| AMENDMENT OF SOLICITATION / MODIFICATION OF CONTRACT | | | 1. Contract Number | Page of Pages 1 1 |
| 2. Amendment/Modification Number DCKT-2011-B-0016-0007 | 3. Effective Date See 16C Below | 4. Requisition/Purchase Request No. | 5. Solicitation Caption Build-Out of Tire Shop | |
| 14. Description of Amendment/Modification (Organized by UCF Section headings, including solicitation/contract subject matter where feasible.) Solicitation DCKT-2011-B-0016 is amended to include November 24, 2010 Pre-Bid Site Visit Attendance sheet. | | | | |

Formal Questions to Solicitation DCKT-2011-B-0016

Double gate Arrangement

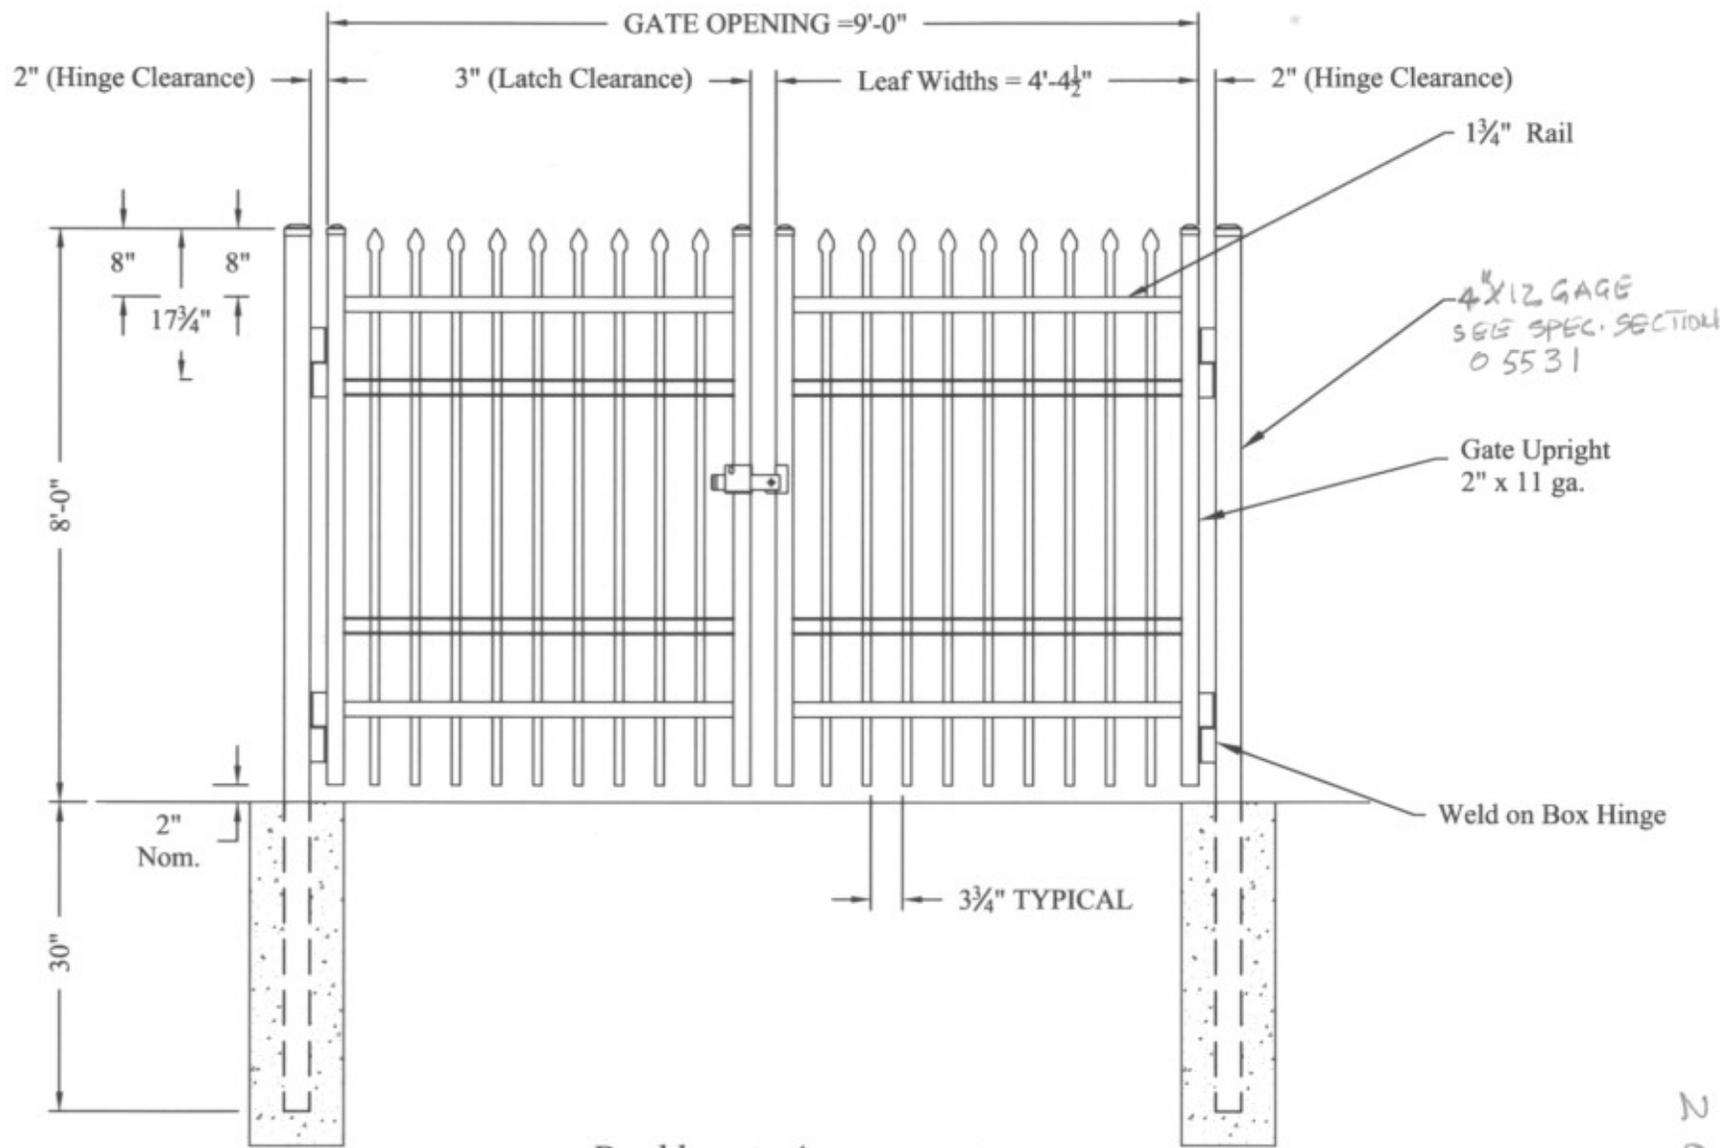
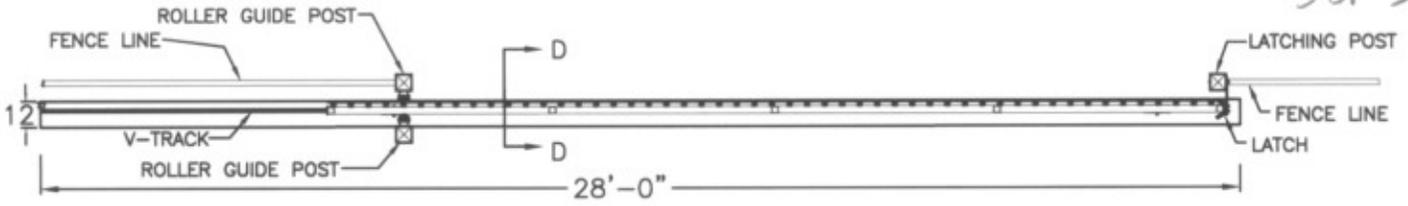
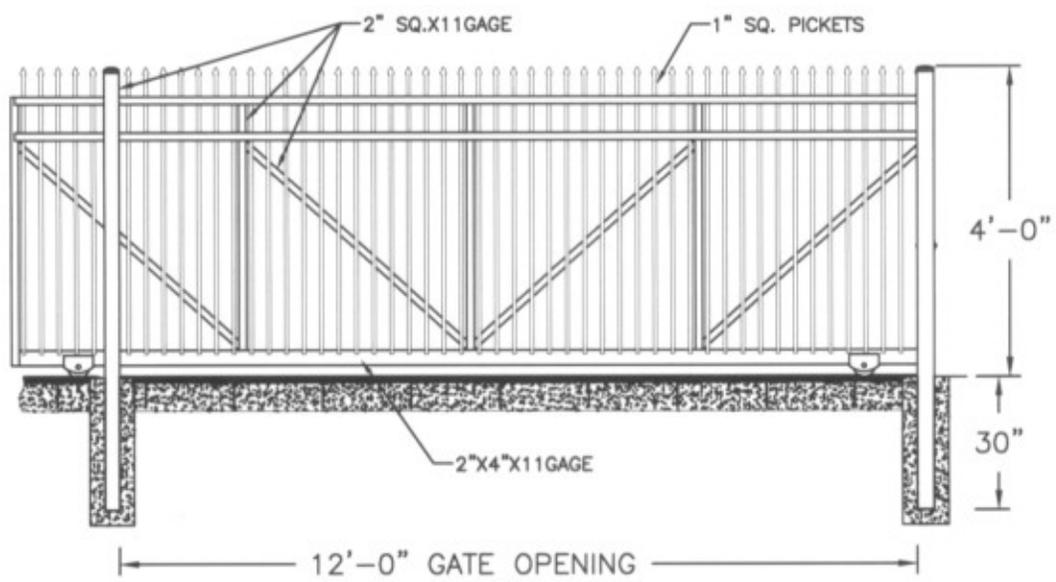
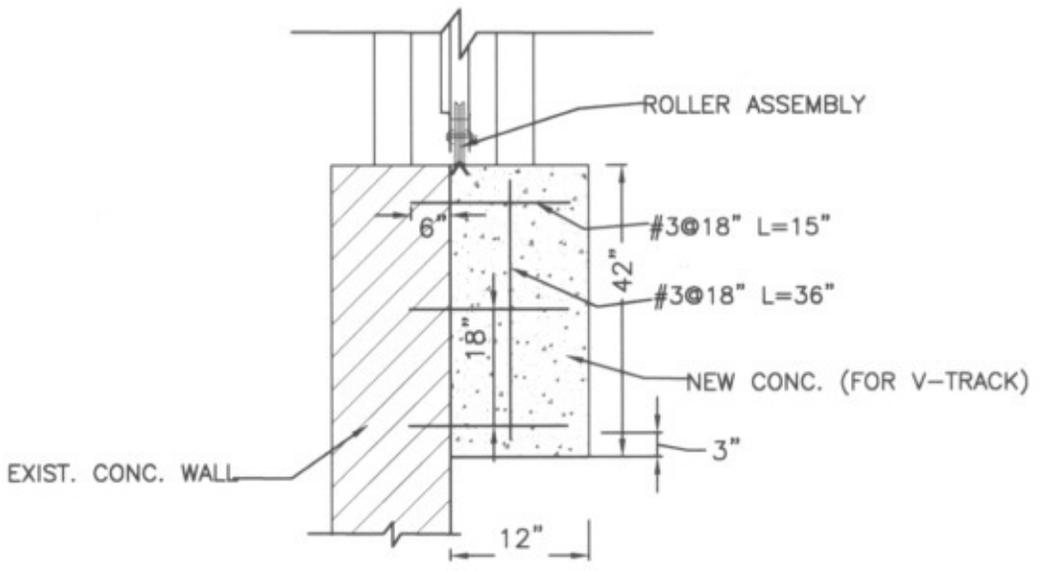
| | ITEMS | QTY'S | UNITS |
|----|---|-------|-------|
| C) | Missing Window opening/closing crank handles | 50 | EACH |

Q54. Drawing C-2 shows three metal gates. However, there isn't any detail given for these gates. Please provide detail for these items.

- a) Provide details for proposed curb.
A10a. Proposed curb to match existing concrete. Curb in the field.
- b) Provide elevation/details for slide gates. Provide gate height and power operator specification.
A10b. Specs & Details provided 11/10/10.

**RECESSED
TOILET-SEAT-COVER
DISPENSER**

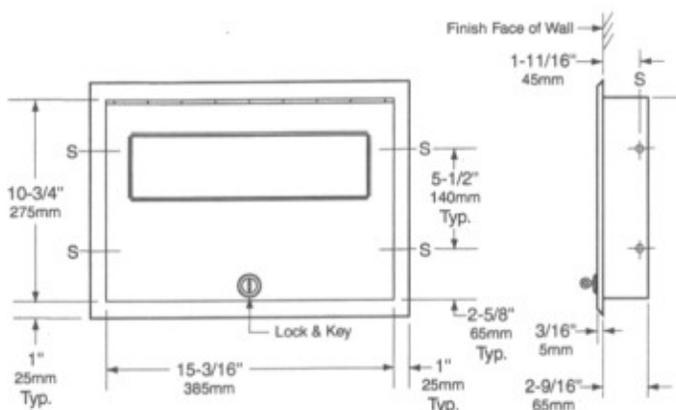
7. ADD the Following Toilet Accessories to those listed in the Specifications Section # 10300 "Miscellaneous Building Accessories"

- a) Toilet Seat Cover Dispenser. (See Sheet #2 of 5)
- b) ADA Grab bars for H/C toilets (See Sheets 3 of 5, 4 of 5 & 5 of 5)

TYP. STAIRCASE AND LANDING GUARD RAIL

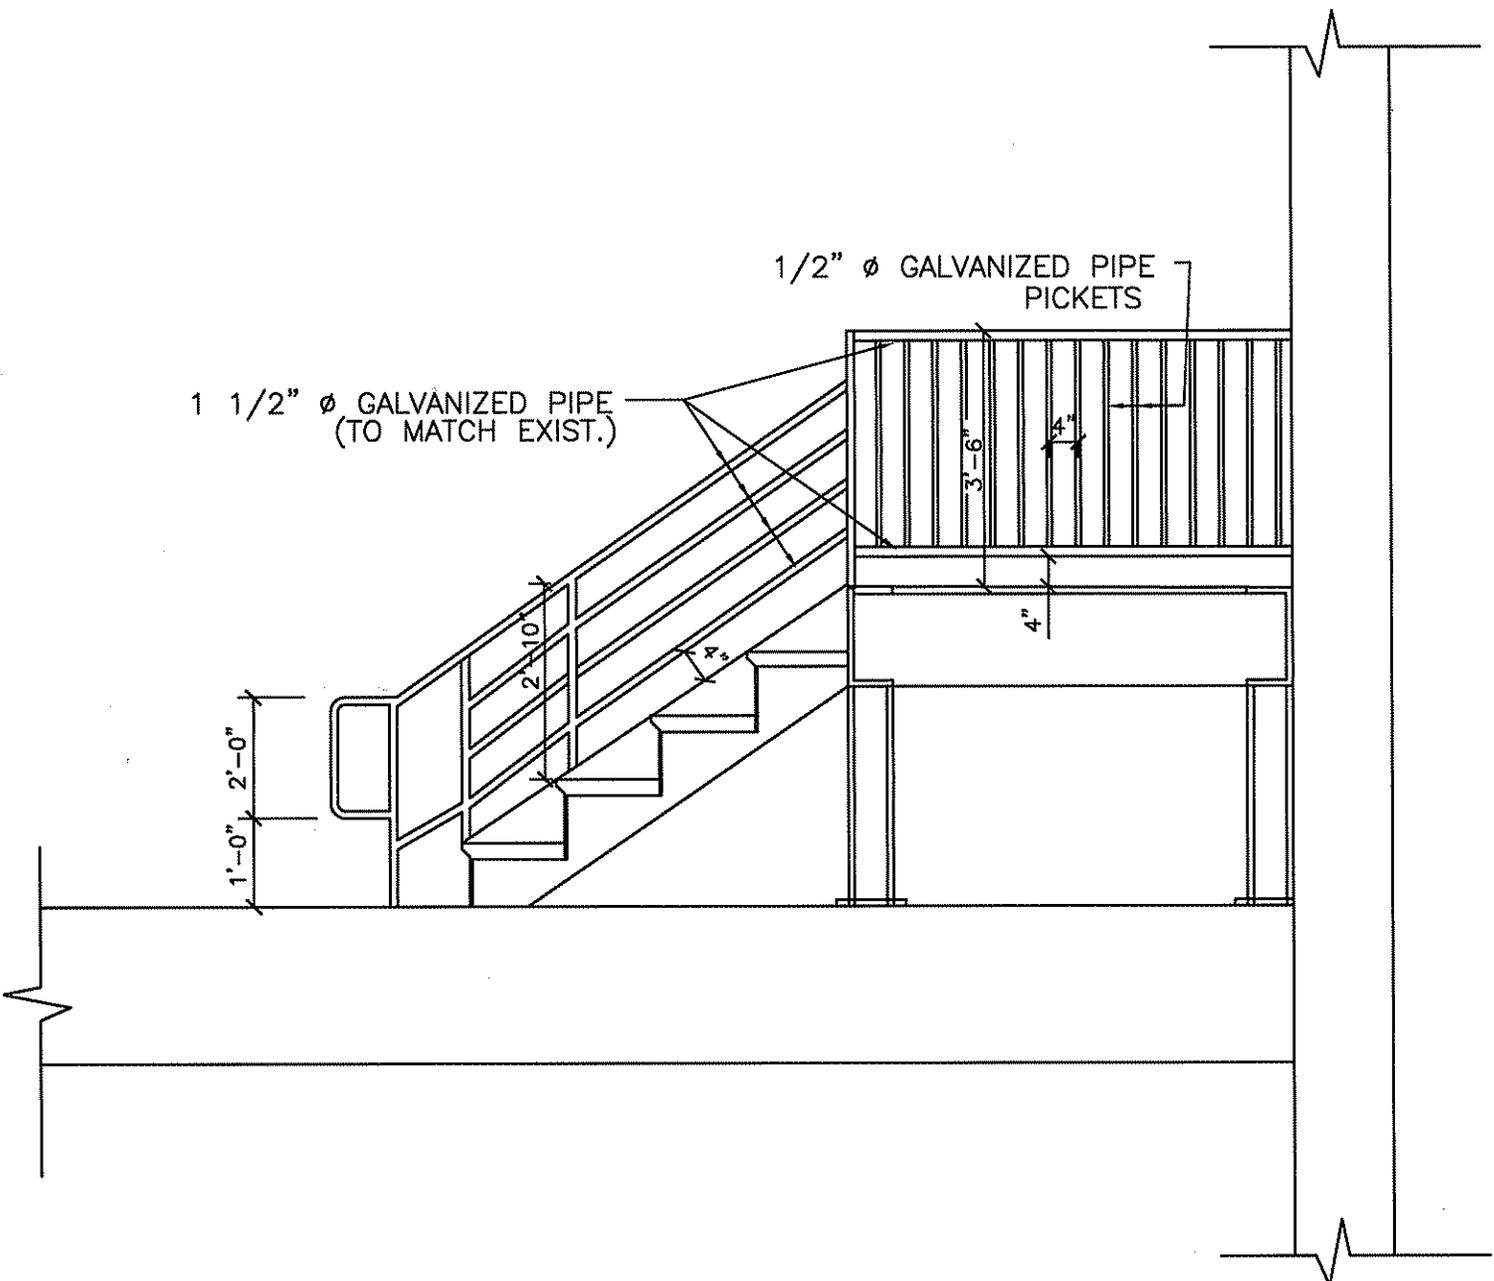
3. ADD Quantity for missing stair & Landing Railings for stair #1 and stair #2 150 LF
